RESPONSE TO REQUEST FOR ADDITIONAL INFORMATION DATED July 15 2014

REGARDING LICENSE RENEWAL

FOR THE UNIVERSITY OF CALIFORNIA, IRVINE NUCLEAR REACTOR FACILITY

LICENSE NO. R-116

Figure 1. UCI Reactor Organization Chart

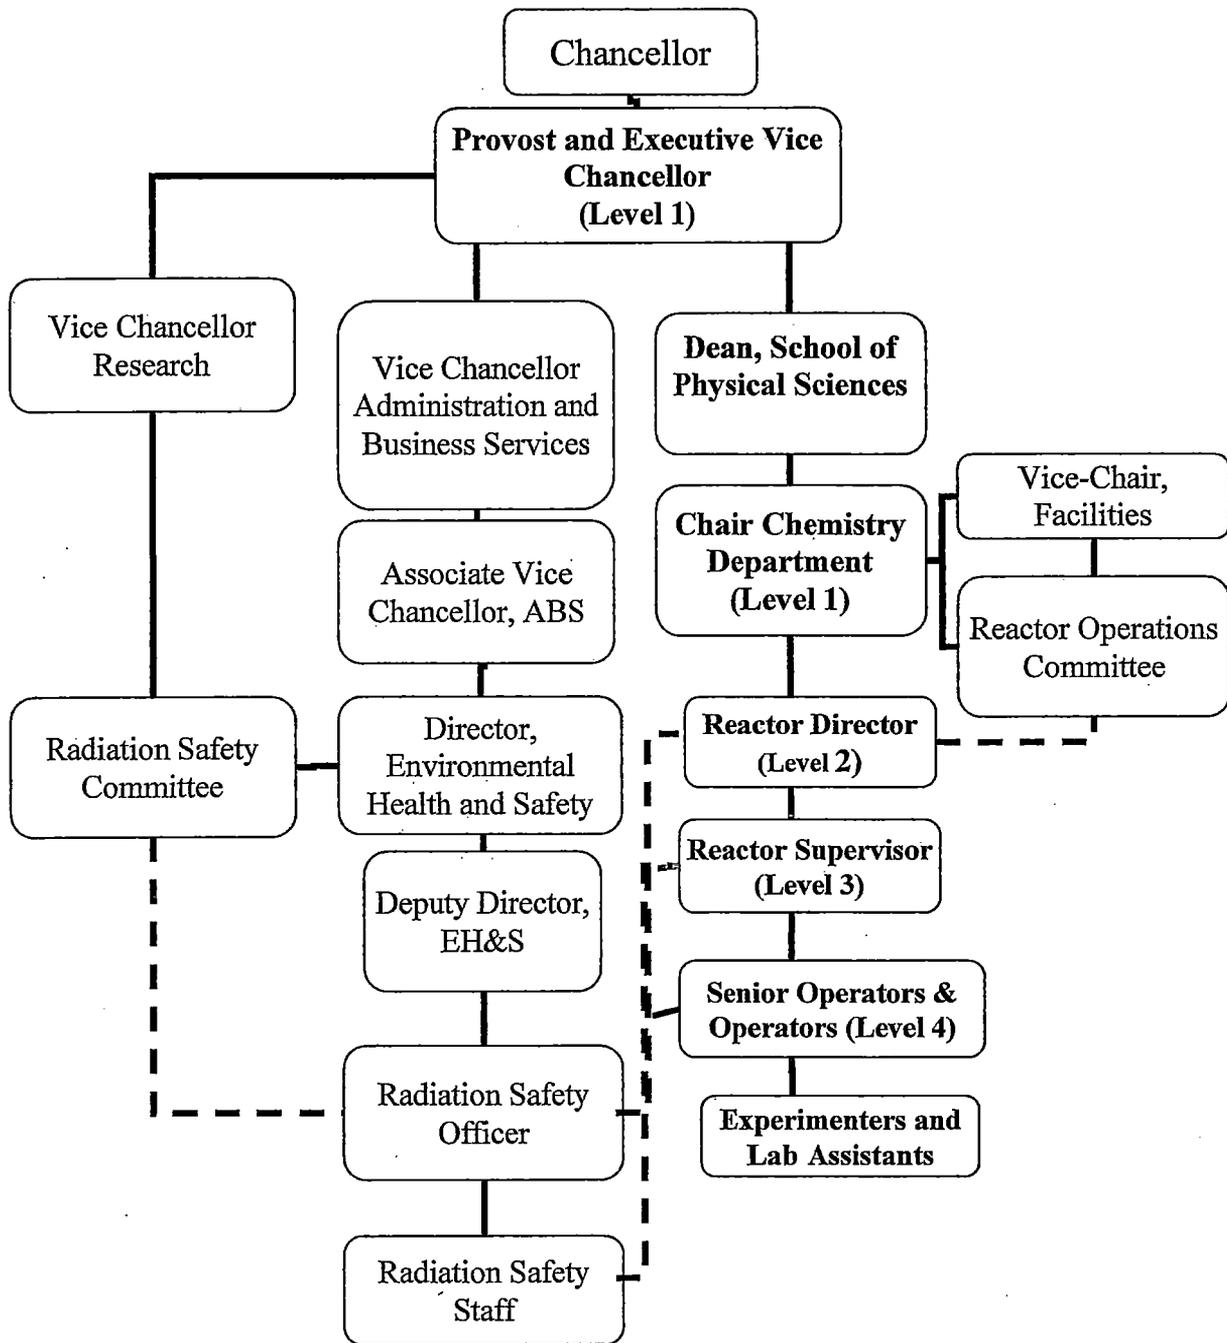
29) *The UCINRF proposed TS 6.1.2, "Responsibilities," "Figure 1. UCI Reactor Organization Chart," requires clarification. The solid-line and dashed-line relationships are not identified in a ledger or within TS description. Confirm and indicate what these connections mean.*

The reactor facility is housed in the School of Physical Sciences of the University of California, Irvine. The reactor is related to the University structure of positions shown in the organization chart, Figure 1, where solid lines represent direct reporting responsibility, dashed lines indicate working relationships.

Ramp Analysis

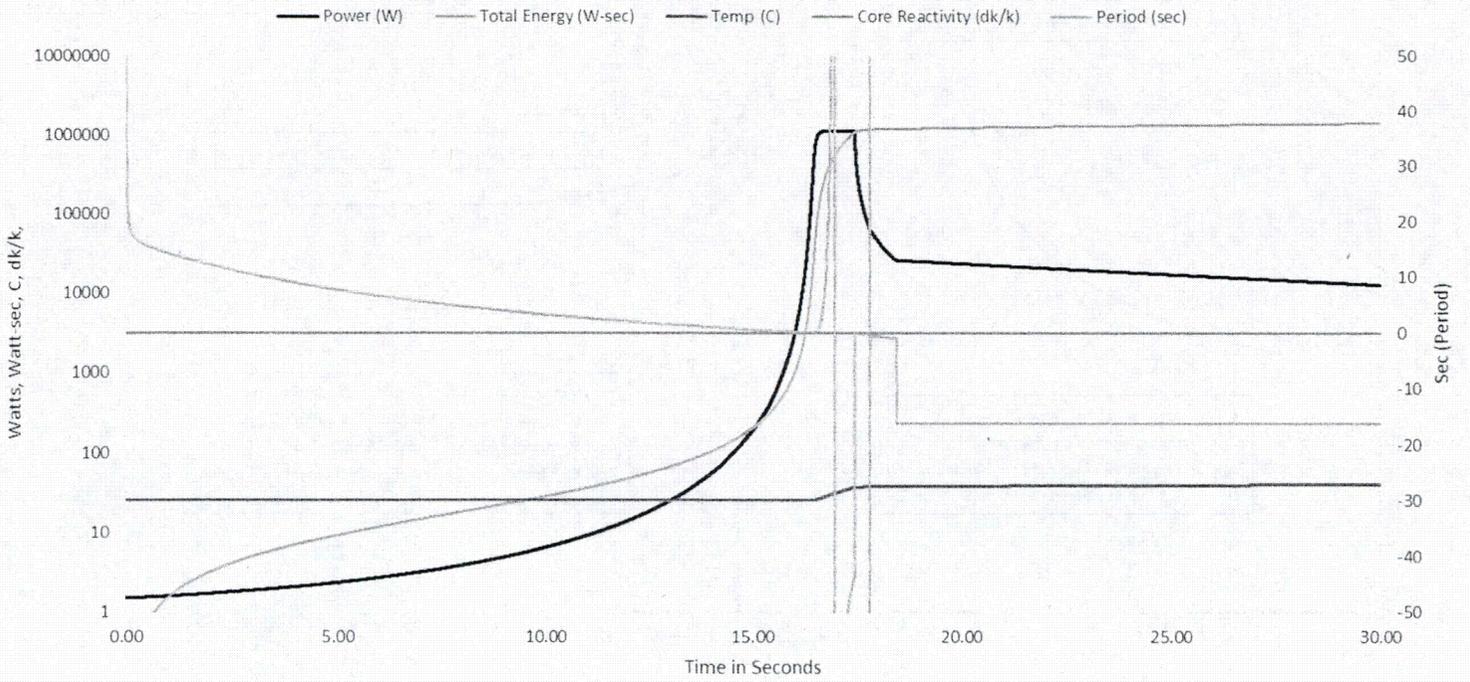
7) *NUREG-1537, Part 1, Section 13.1.2, "Insertion of Excess Reactivity," lists insertion-of-excess-reactivity events which includes a ramp insertion of reactivity by drive motion of the most reactive control or shim rod, or ganged rods. Provide details of the ramp insertion analysis including the reactor trips in order to demonstrate the protection of the safety limit.*

However, in response to this request a slow drive ramp insertion analysis has been conducted and the results are presented and discussed in an attachment to this document.

1. Power, Energy, Fuel Temperature, Reactivity and Period over the 30 second time of a RAMP.
2. Power and period changes determined over the significant time period 16-17 seconds into the RAMP.
3. An annotated plot of the simulation results over the "excursion" time period of the event from 15.0 to 20.0 seconds.
4. A detail of power and period through the predicted scram at 17.42 seconds into the RAMP.
